Product Change Notification

Change Notification #: 860576-01

Change Title: Select Intel® Ethernet Network Adapters
Reason for Revision: Updating the PBA# for MM#983099

Change Detail: Updated NVM, UKCA address, China RoHS QR code, and label removal

Disti Label Example showing where the new UKCA SPOC and China RoHS QR codes are printed

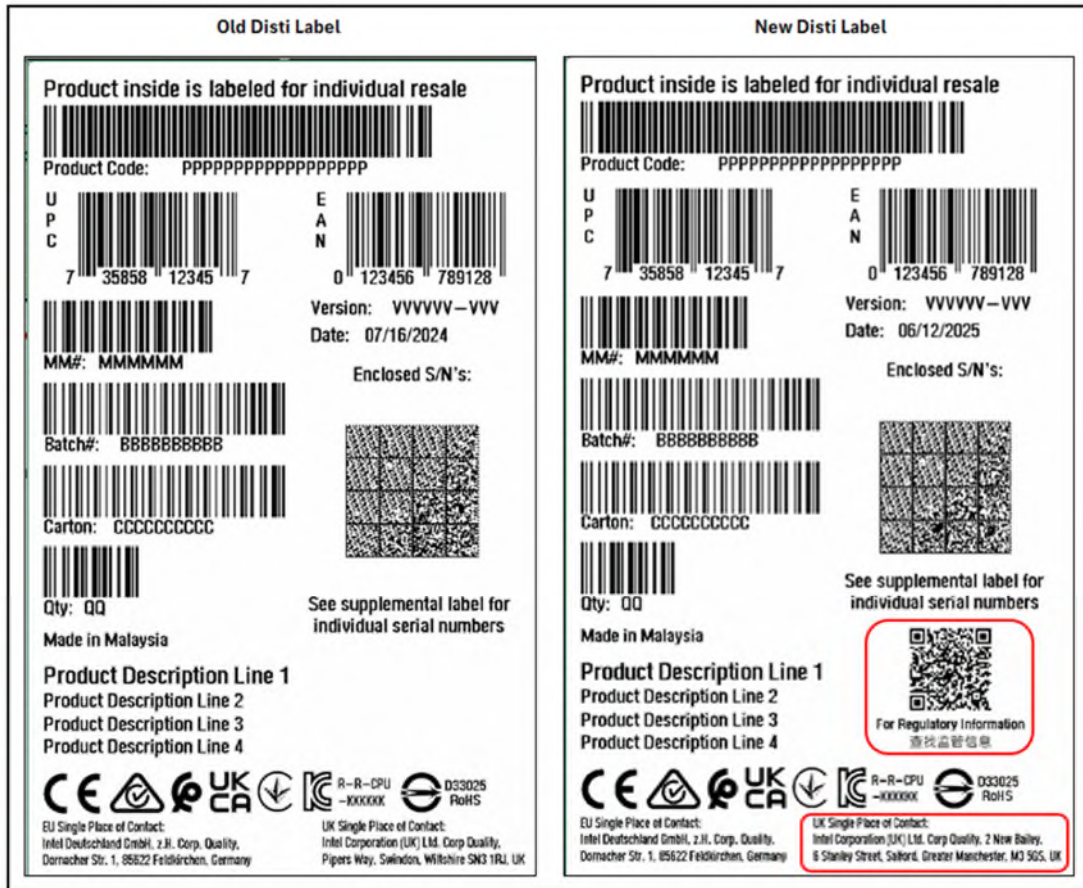
- Then, select the “Non-Volatile Memory (NVM) Update Utility for Intel® Ethernet Network Adapter E810 Series.
- UKCA CE Directives require a UKCA based 'Single Place of Contact' (SPOC) address for products entering the UK (United Kingdom), which Intel currently prints on the outer box label of products. Intel is exiting the current site of the UKCA SPOC address at the end of September 2025 and moving to a new site, requiring the UKCA SPOC address to be updated to the new site on labels and products shipped by October 1, 2025. The UKCA SPOC address that is printed on the labels will be updated on all of the products listed in Products Affected/Intel Ordering Codes table.

The updated address is shown below:

Label images are provided below. (Picture is for example only, to demonstrate the QR and location placement on the Disti/Outer Box Labels; the actual placement is subject to change per different label template). As a reminder, PCN 859226-00 published in July 3, 2025, in which Intel communicated the implementation of the new UKCA address and QR code due to the tight timeline for implementing the UKCA SPOC changes by October 1st, 2025.

UK Single Place of Contact:

Intel Corporation (UK) Ltd., Attn: Corp. Quality, 2 New Bailey,
6 Stanley Street, Salford, Greater Manchester, M3 5GS, United Kingdom

Below is an example of the Anti-counterfeit label that will be removed:

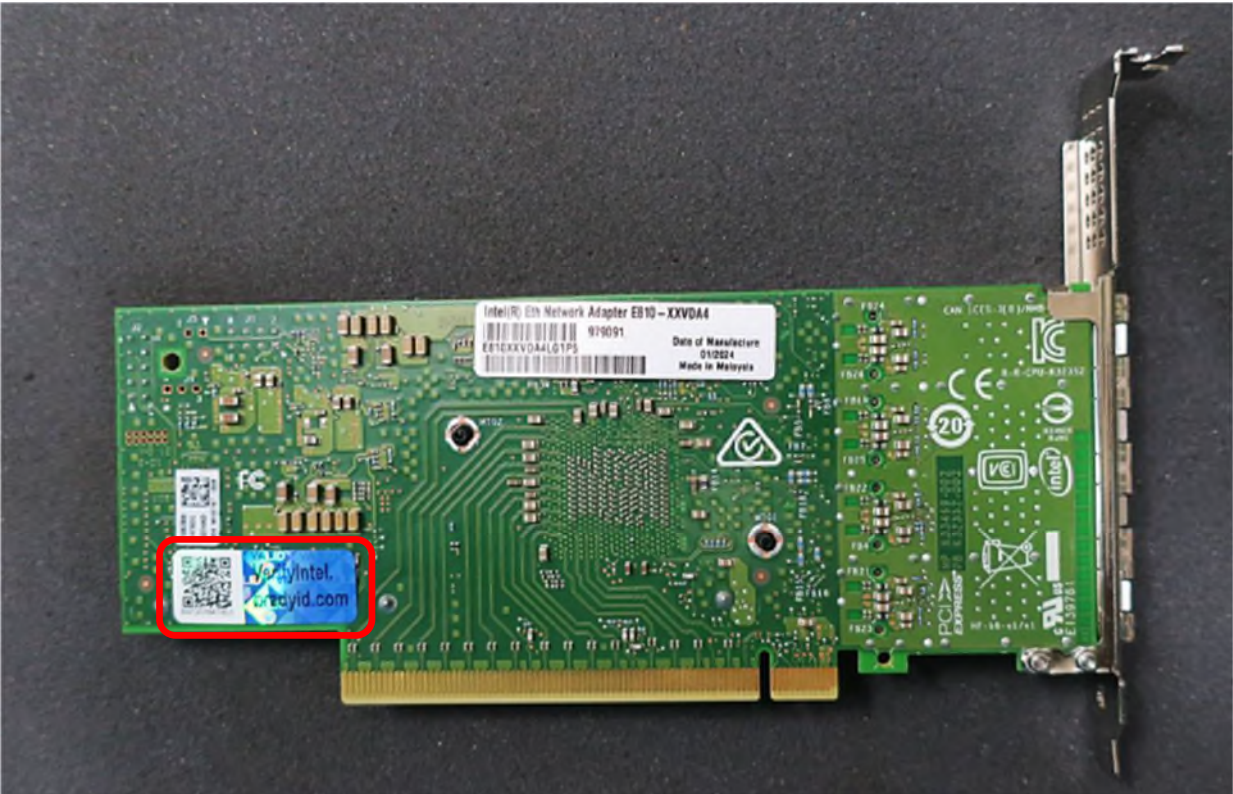
4. These 4 SKUs (E810XXVDA4LG1P5 / E810XXVDA2 / E810XXVDA2BLK / E810XXVDA2G1P5) will have the Anti counterfeit label removed from the product.

Due to the board design with many components, lead protrusions, regulatory markings and traces that cannot be covered, there is not sufficient area available for this label to stay securely affixed to the product. As a result, the label may become loose and, in some cases, detach from the board.
